Service Bulletin

Bulletin No.: 24-NA-156

Subject: Information on Dealer Installed Accessory Trailer Hitch Installation Concern

6692657

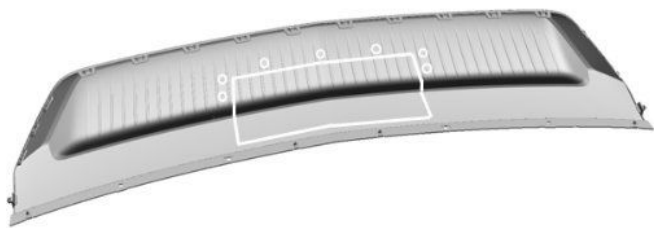
During Installation, on the inside of the rear fascia skid plate, check to see if there is a scribed line (1) present in the location shown. If no scribed line is present:

- For Chevrolet Equinox EV, a new rear fascia skid plate P/N 85629520 must be ordered before proceeding to the next step.

- For Cadillac Optiq, a new rear fascia skid plate P/N 85511282 must be ordered before proceeding to the next step.
